# Access Compliance Report

## Public Rights-of-Way

### (Curb Ramps)

| Intersection ID: 46820                  | Main Street: NORWAY_SPRUCE_CT | Cross Street: AZALEA_HILLS_DR           | Location: E            |

| ADA ID: 81A6E3A9B581                    | Ramp Type: PerpDiag           | Initial Pass/Fail: Fail                 | Overall Compliance: No |

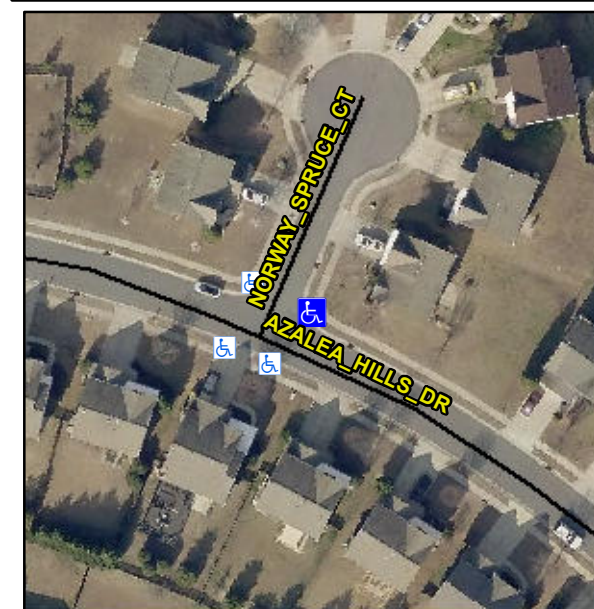
**R304.5.1, R304.2.2**

| Compliance | Description           | Data  | Compliance | Description                 | Data  |
|------------|-----------------------|-------|------------|-----------------------------|-------|
| N/A        | Ramp Length (in)      | 47.0  | No         | Ramp Slope (%)              | 10.7  |
| No         | Ramp Width (in)       | 46.5  | Yes        | Ramp XSlope (%)             | 0.2   |

**Remove & Replace Curb Ramp With Two New Directional Ramps or Equivalent.**
